Certificate of Appropriateness

Property 4243 W. NORTH AV. Sherman Boulevard HD
Description of work Install painted/opaque stained wood fence on south property line. Install bike rack at corner. Upgrade parking lot amenities per attached plans. Install metal picket fence along Sherman Boulevard south of driveway.
Date issued 9/7/2018 PTS ID 114625 COA: fences, bike rack, landscaping

Finney Mercantile + Future Restaurant

Meta Sample metal picket fences and model of bike rack

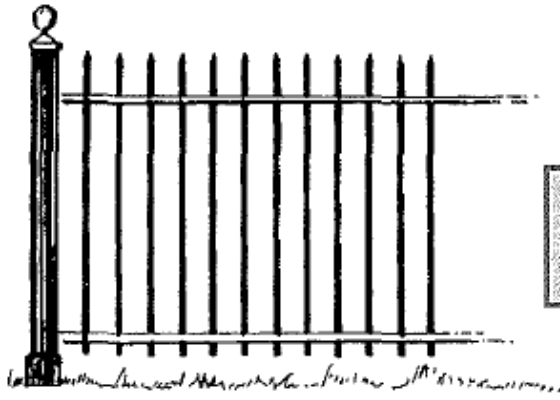
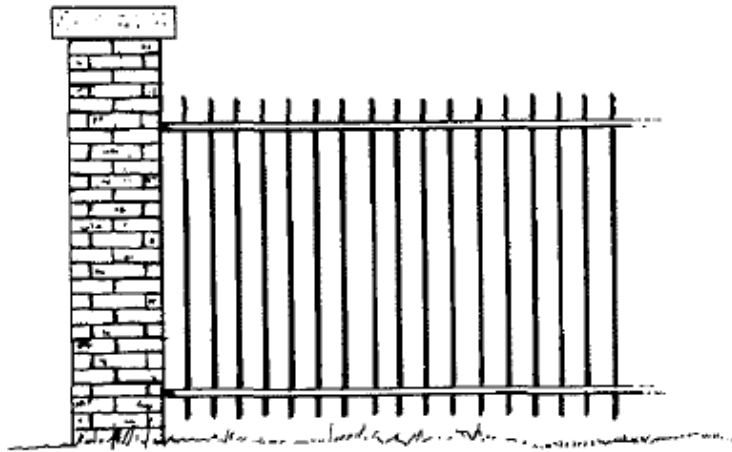
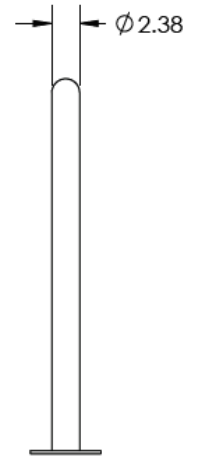
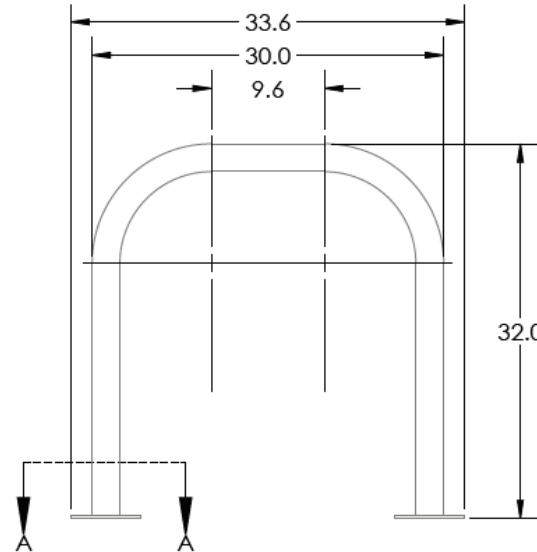
Metal Fence at south of driveway on Sherman Boulevard shall be painted/powder-coated square pickets. A typical approvable example is attached, an exact match is not required.
